**From:** Freemon, Robert  
**Sent:** Tuesday, November 22, 2016 10:27 AM  
**To:** 'md.monroe@gmail.com'  
**Cc:** 'tonygage30@gmail.com'; 'coveyconsulting@gmail.com'  
**Subject:** 12671 Lime Kiln Rd.  
**Attachments:** 12671 Lime Kiln Rd.pdf; HCHD BP Process.pdf; OSDS design plan requirements 11.21.16.pdf; Well & Septic SETBACKS.pdf; ENGINEERS Surveyors REV 6-28-02.doc

### MEMORANDUM

RE: 12671 Lime Kiln  
Fulton, MD 20759  
**"Before BP Approval"**

I have reviewed the building permit for 12671 Lime Kiln Rd. and here are my comments.

PROPOSED SECOND FLOOR PLAN

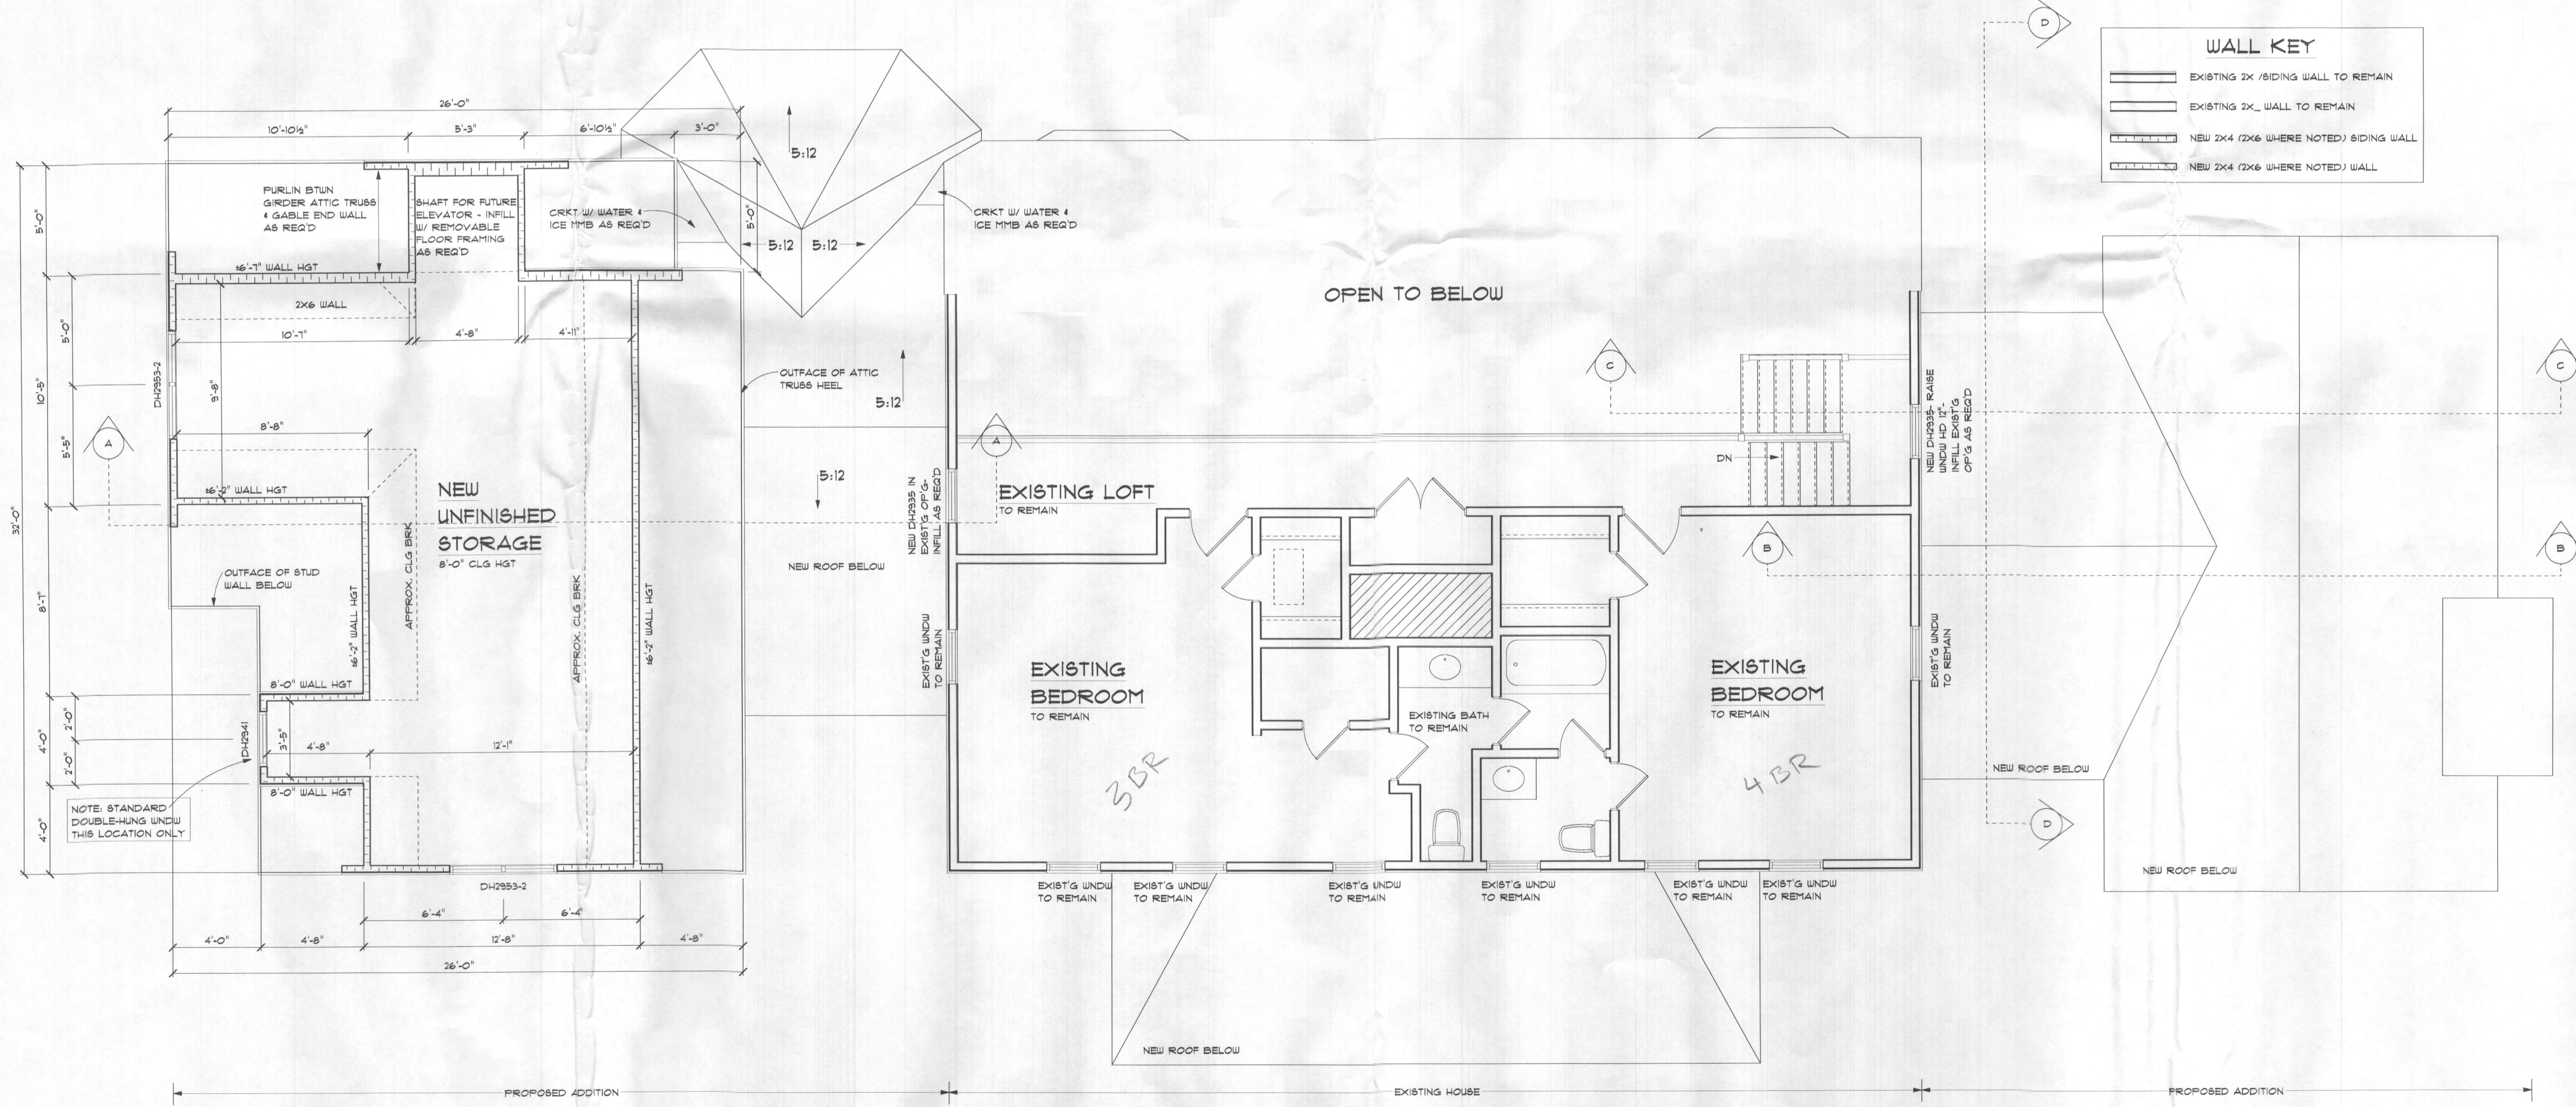
- An on-site sewage disposal system upgrade is required. The existing septic system installed in 1968 was designed and sized to serve 2 bedrooms. The submitted floor plans of the existing house with the addition show a total of 4 bedrooms (1<sup>st</sup> Floor: Office, Relocated Bedroom; 2<sup>nd</sup> Floor: Existing Bedroom, Existing Bedroom) based on the Howard County Code definition of a bedroom (Sec. 3.801[b]). The floor plans also indicate the total square footage of the proposed house to be over 1,500sqft which requires a 1,500 gal septic tank (Sec. 3.810[b, 2]).

- A Residential Septic System permit will need to be applied for along with the fee of \$395 paid to the Director of Finance. A Septic System Site Plan will need to be created and approved by the Health Dept. See the attached design plan guidelines. Once approved we may issue the septic permit and the system must be installed and approved (with abandonment of the old system) prior to Health approval of the BP.
